February 9, 2018

**Re:** Responses to Comments of Cell 17 Draft Substantial Modification Application  
Pasco County – Solid Waste  
Facility Name: Enterprise Road Class III Recycling and Disposal  
Facility Site ID: 87895  
DEP Application Nos.: 177982-023-SC/T3 and 177982-024-SO/T3

Thank you for your review of the above-referenced permit modification draft for the Enterprise Road Class III Recycling and Disposal Facility. The following information is provided in response to the FDEP's draft comments email dated October 17, 2017. Information is provided in the order requested in the referenced correspondence. In each case, the Department's request is stated in italics with the response immediately following in **bold**.

PROJECT NO.:	02000-217-17
SCALE:	AS SHOWN
DATE:	AUGUST 2017
DRAWING:	C1.00

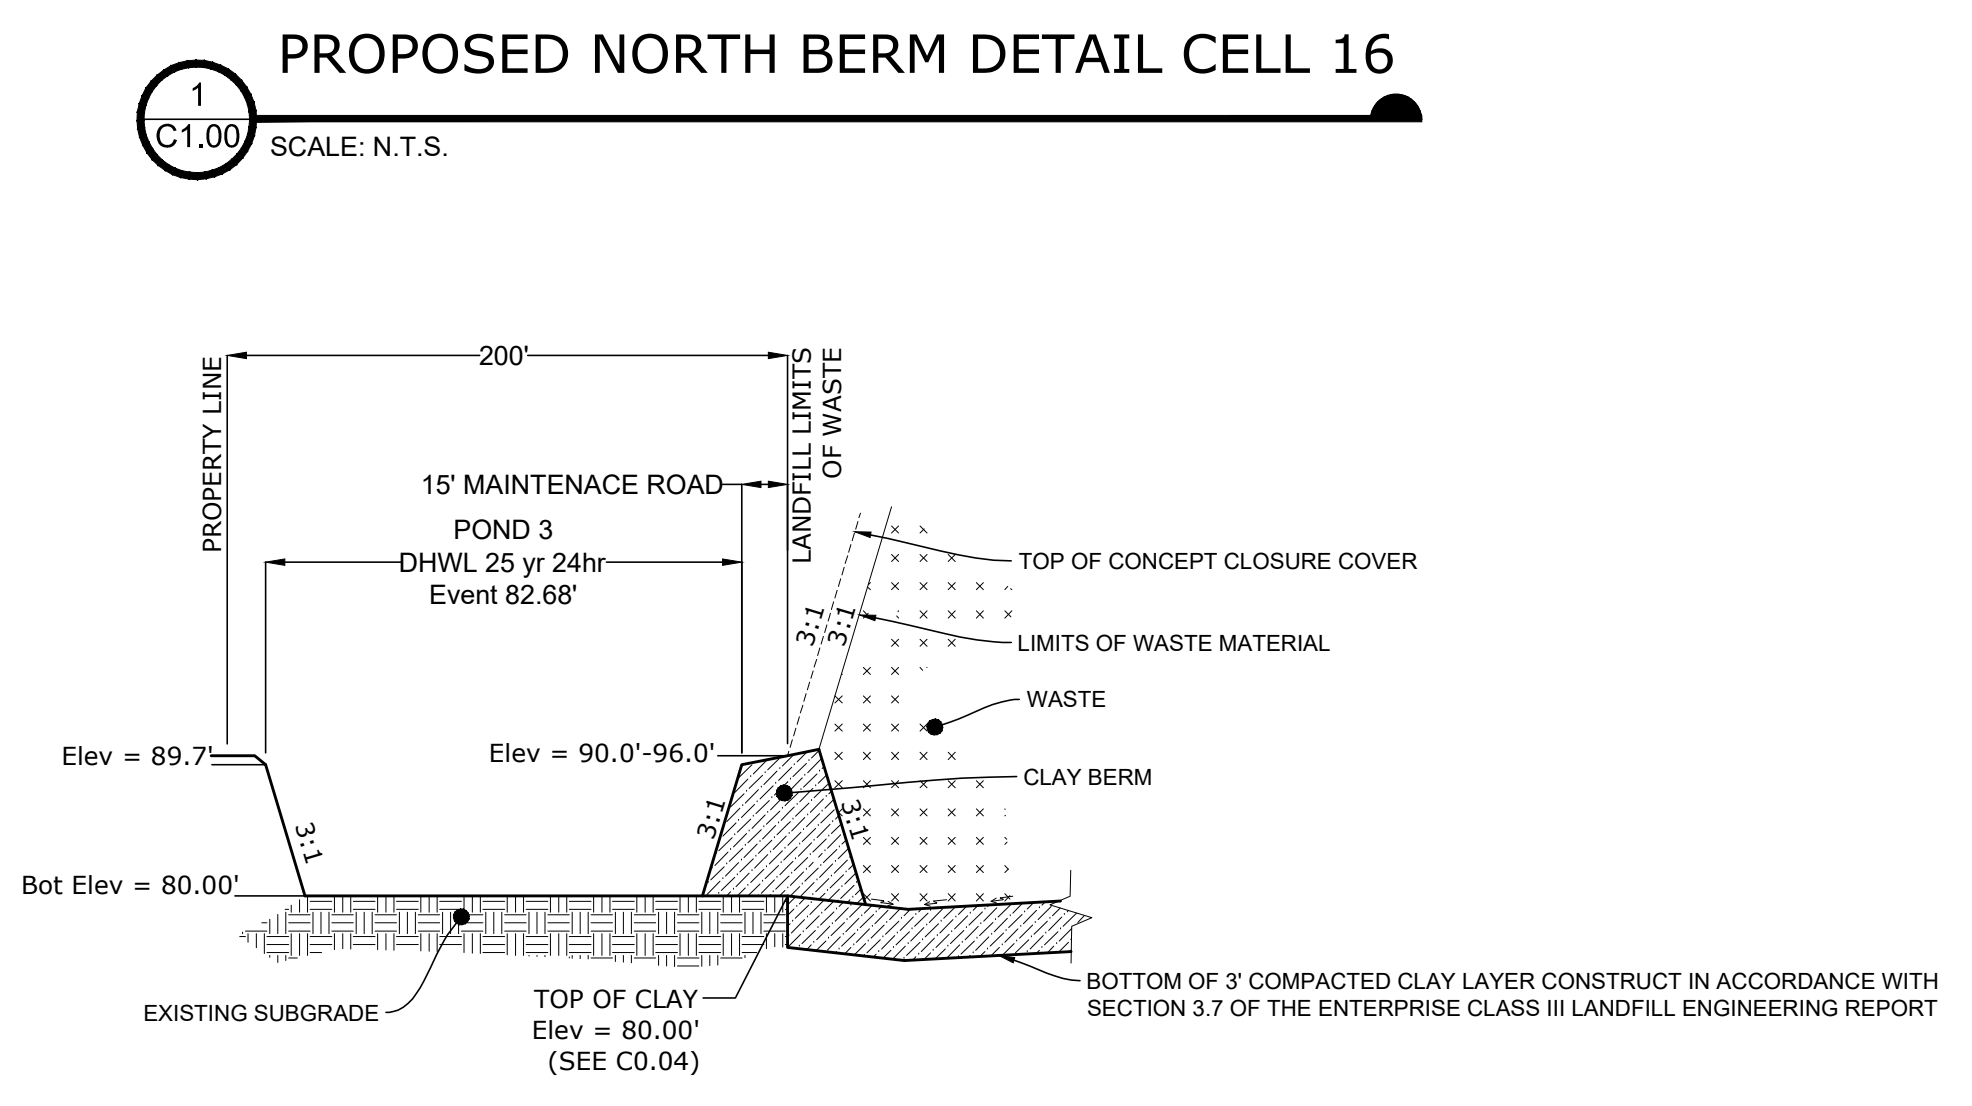
*Comment 45: Drawing C1.00: The Cell 17 toe drain trench and pipe details are not shown on drawing.*

**RESPONSE 45:** Drawing C1.00 has been revised to show the Cell 17 toe drain trench and pipe details.

PROJECT NO.:	02000-217-17
SCALE:	AS SHOWN
DATE:	AUGUST 2017
DRAWING:	C1.01

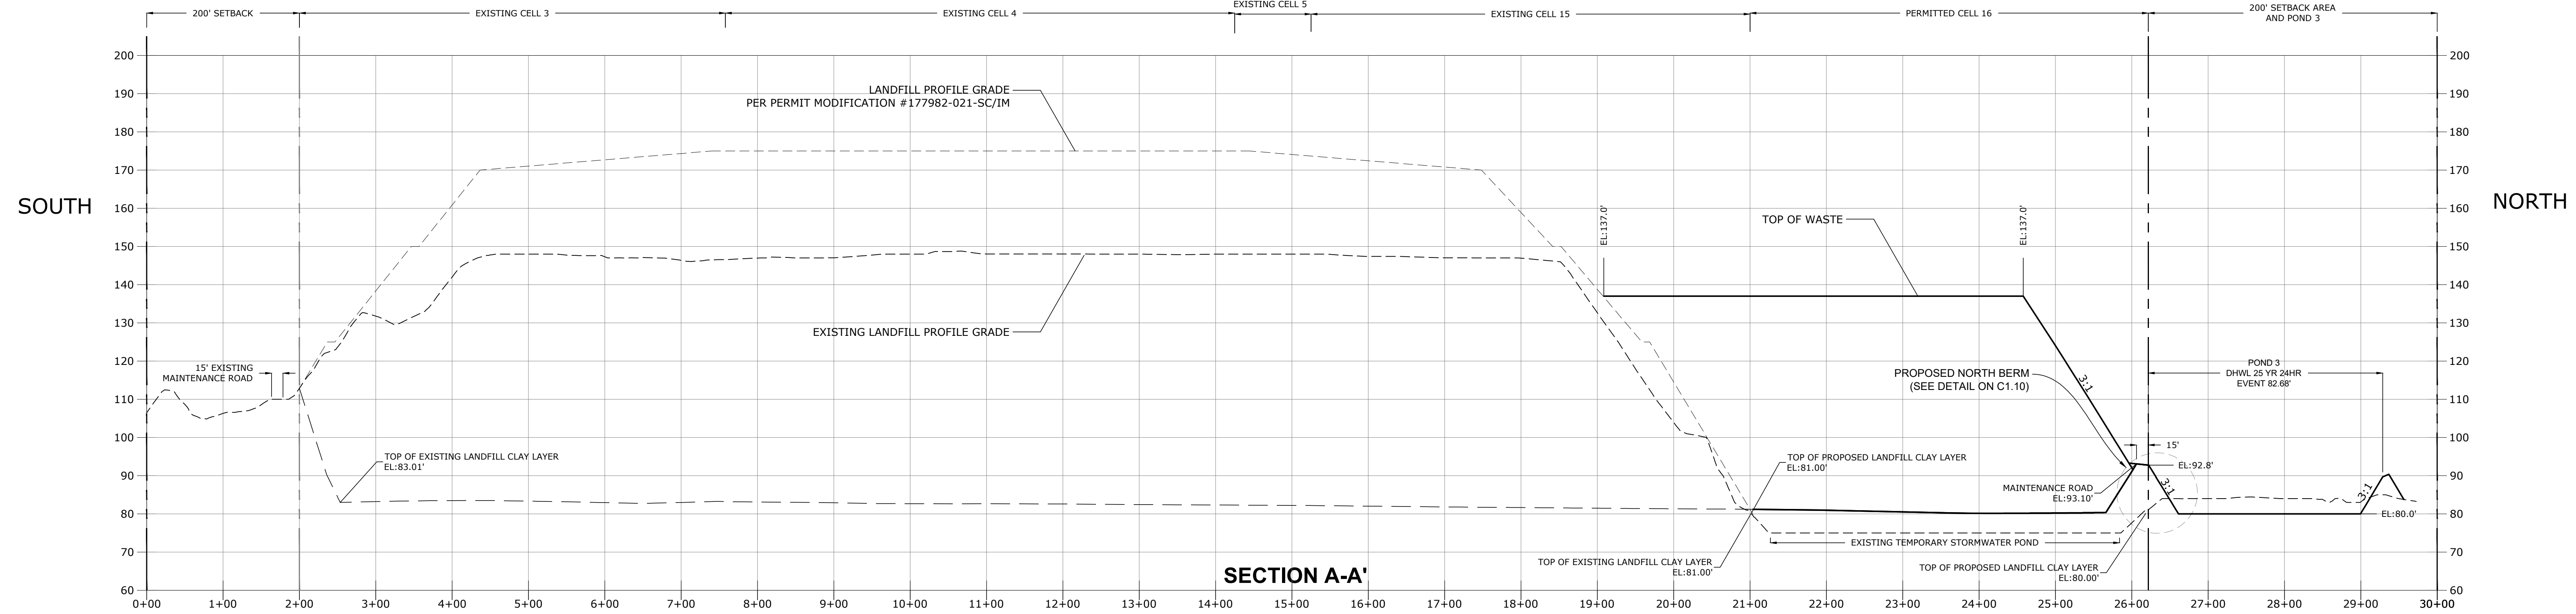
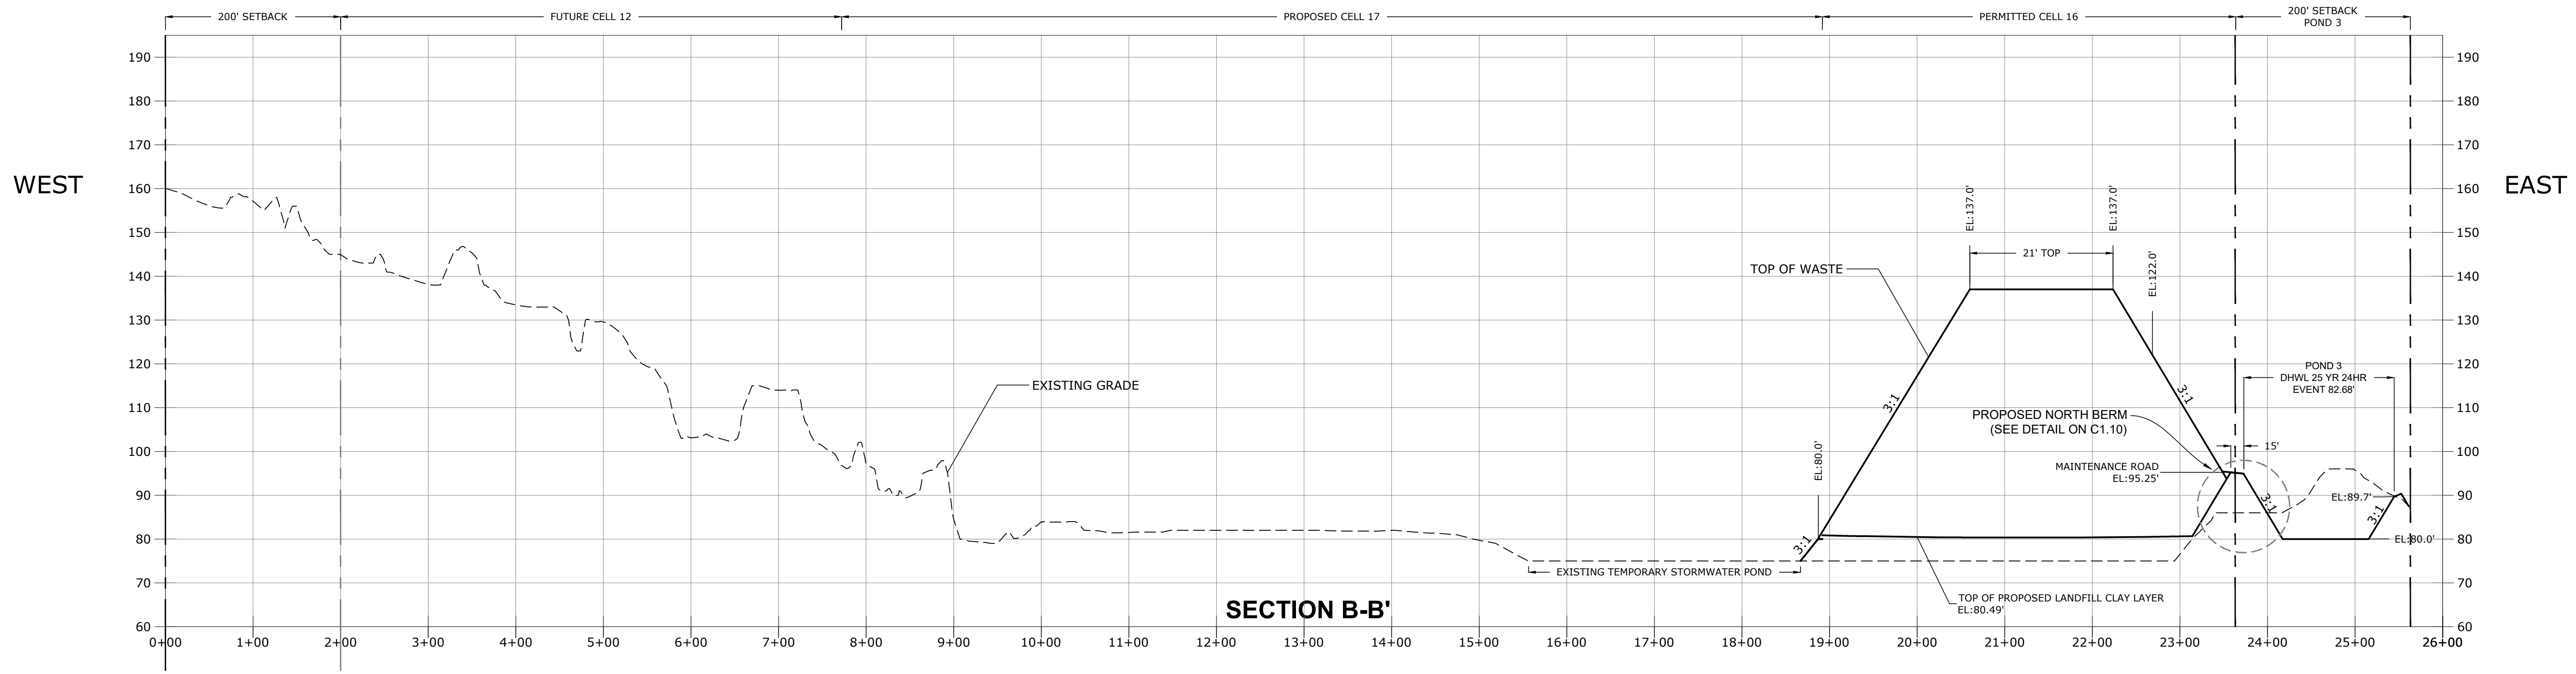
*Comment 46: Drawings C1.01, C1.11, C2.10 and C3.10: The "Permitted Kelner Landfill Profile Grade" was modified by Permit Modification #177982-021-SC/IM. Drawings should be updated accordingly.*

**RESPONSE 46:** Drawings C1.01, C1.11, C2.10 and C3.10 have been revised to include the profile grade in accordance with the referenced permit modification.

PROJECT NO.:	02000-217-17
SCALE:	AS SHOWN
DATE:	AUGUST 2017
DRAWING:	C2.00

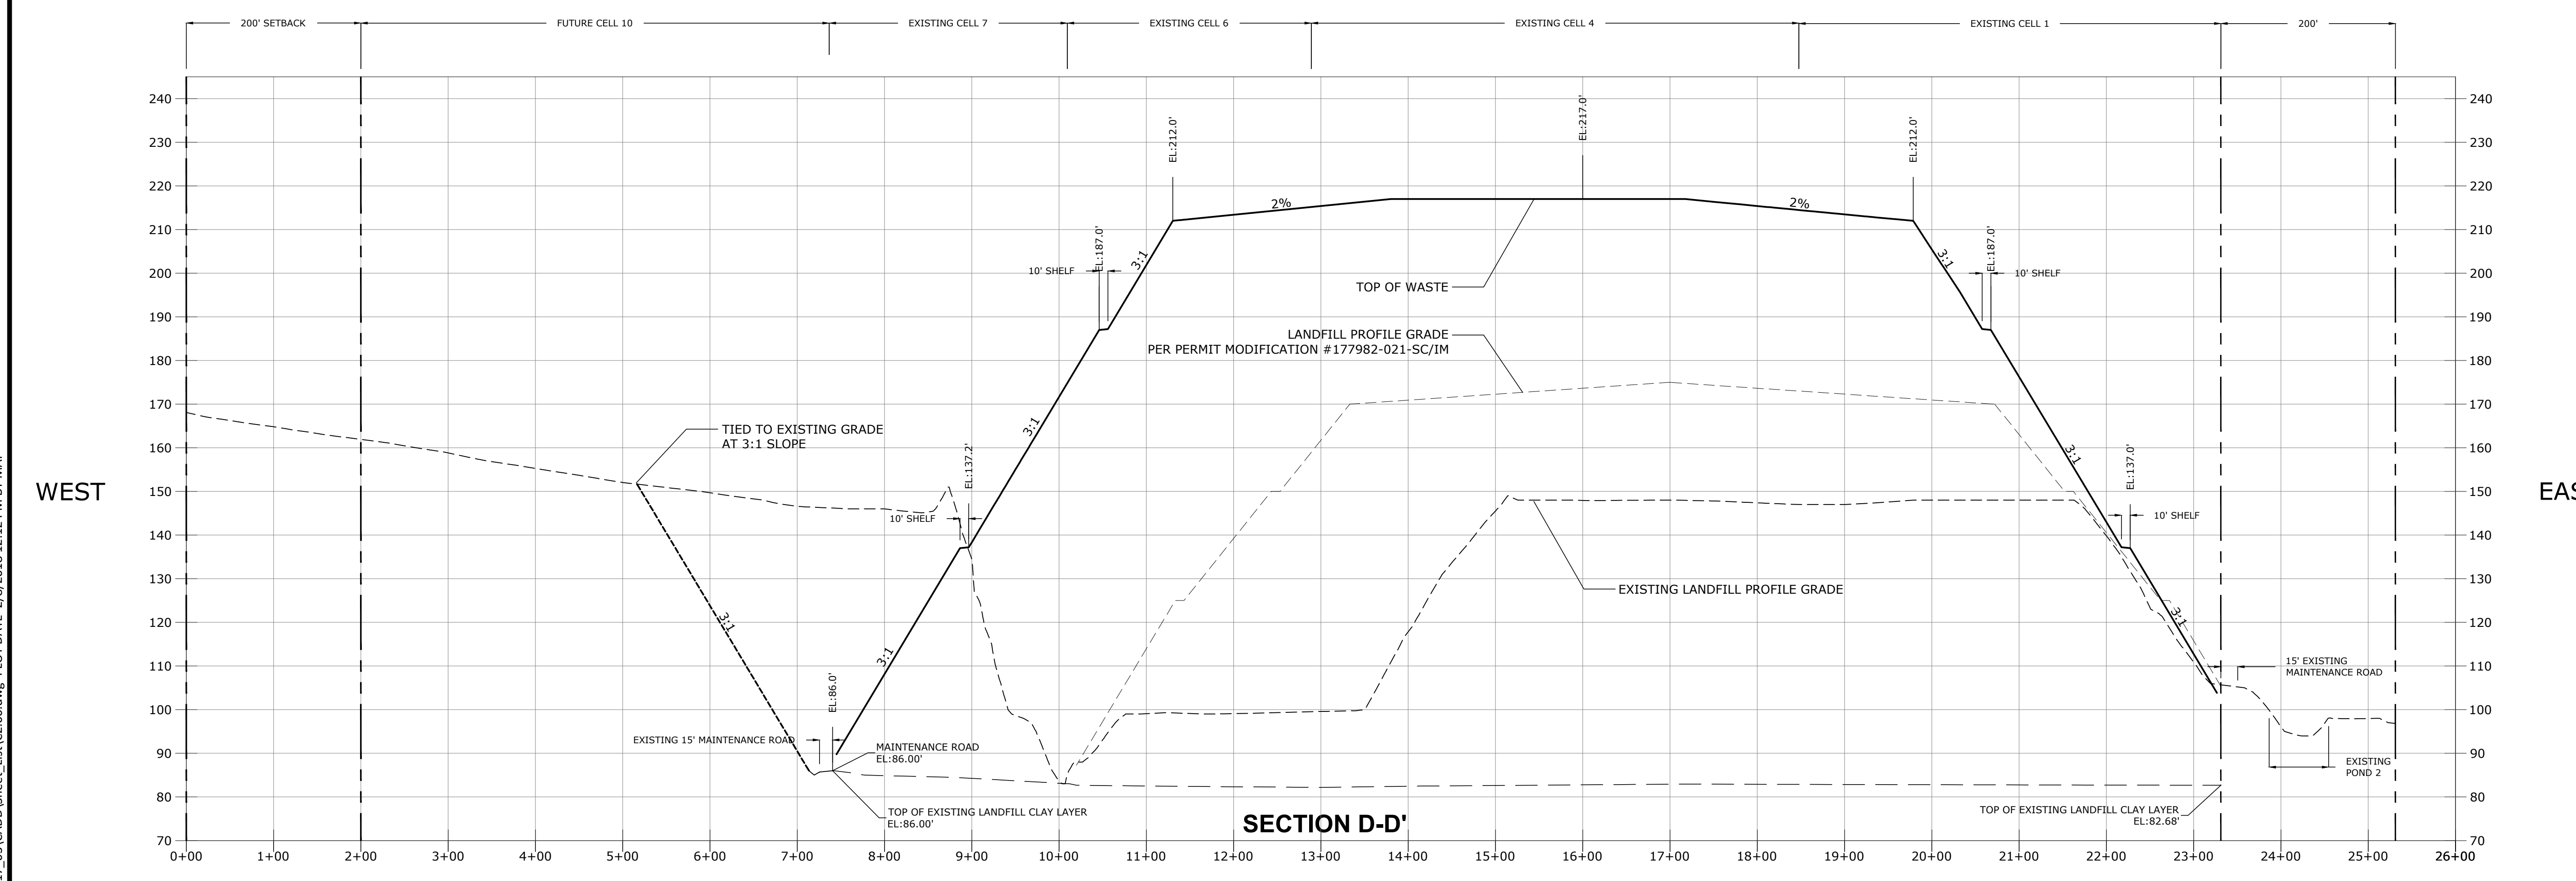
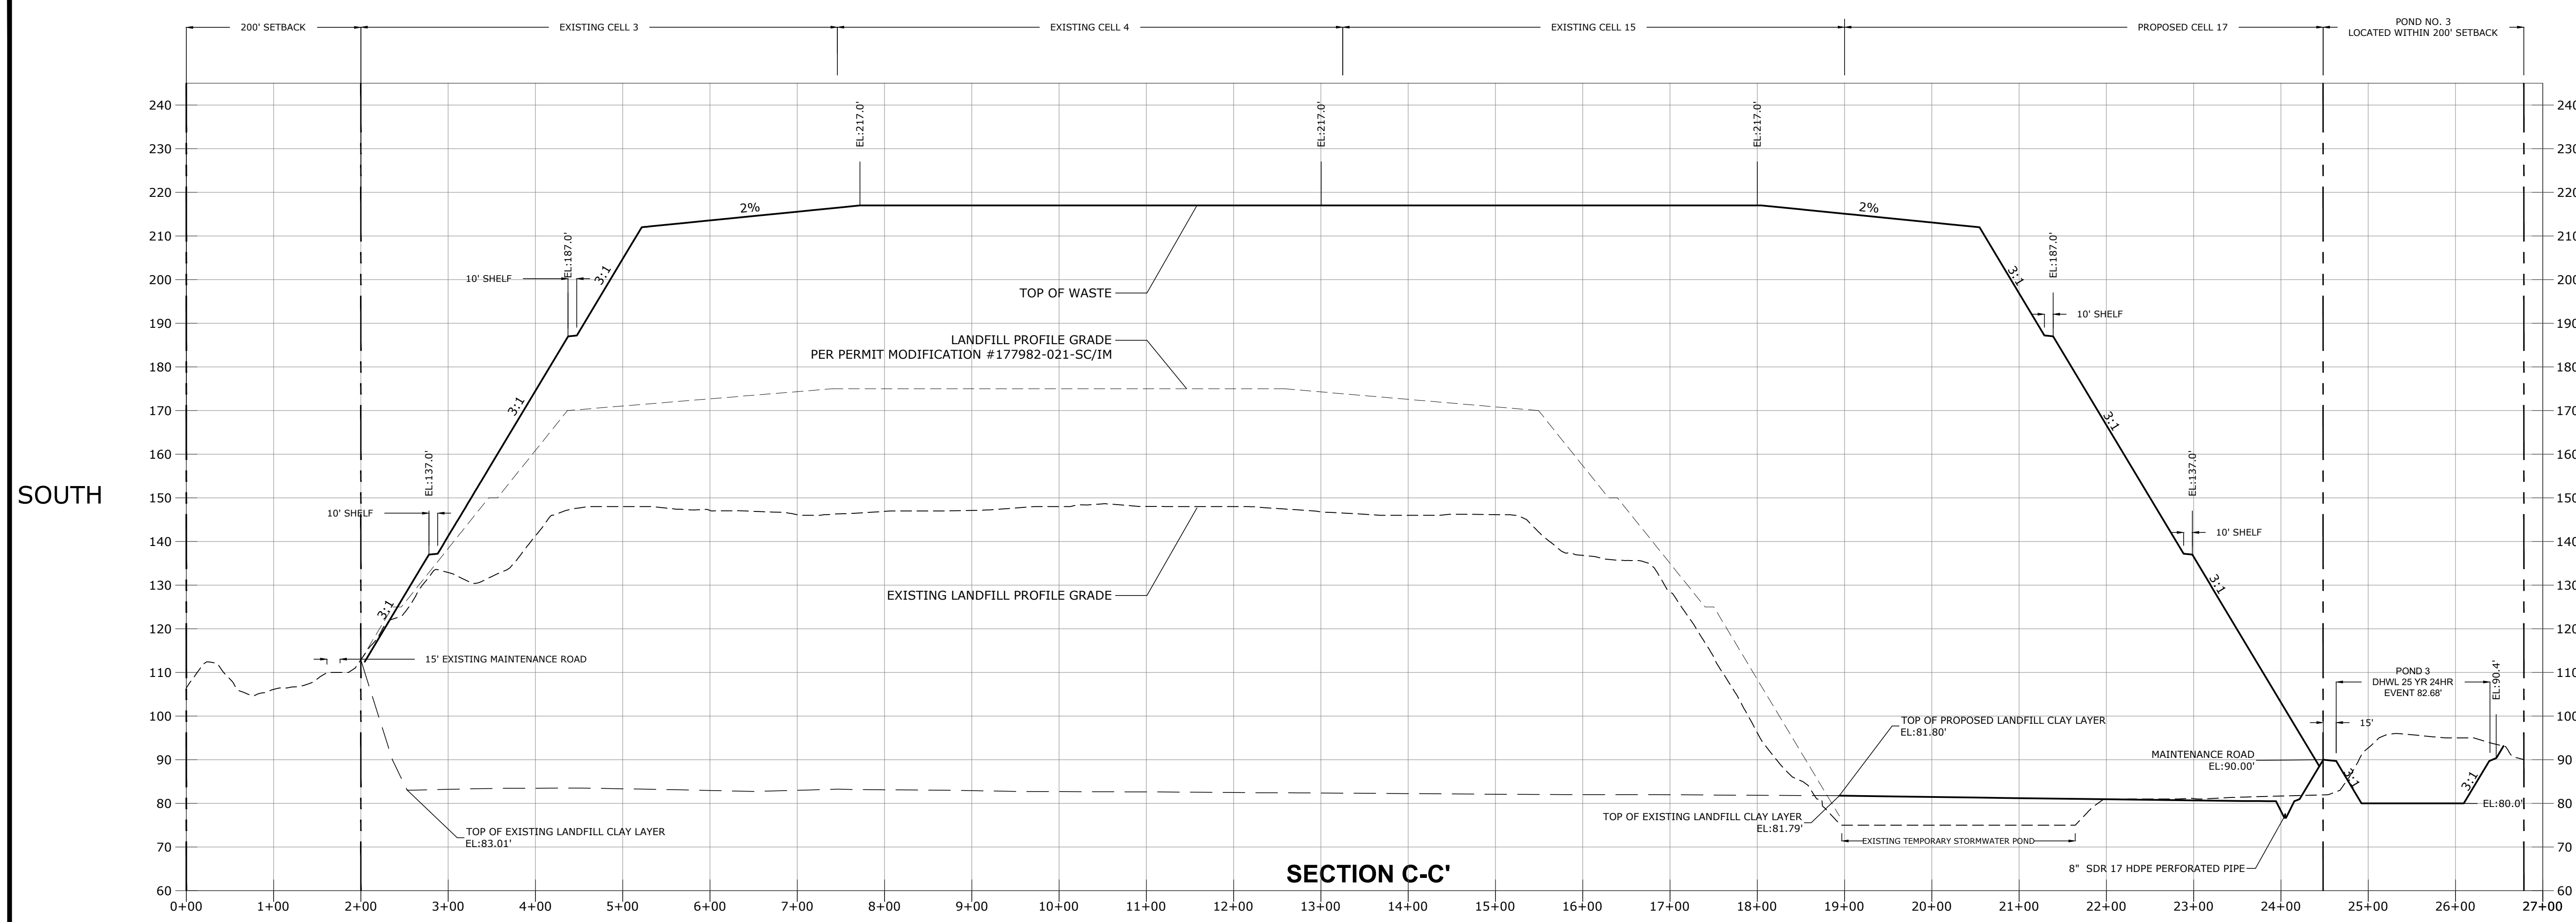
*Comment 47: Drawing C2.00:*

**RESPONSE 47:** The Cell 7 west conveyance swale will discharge to Pond 3. Please see revised drawing C2.00.
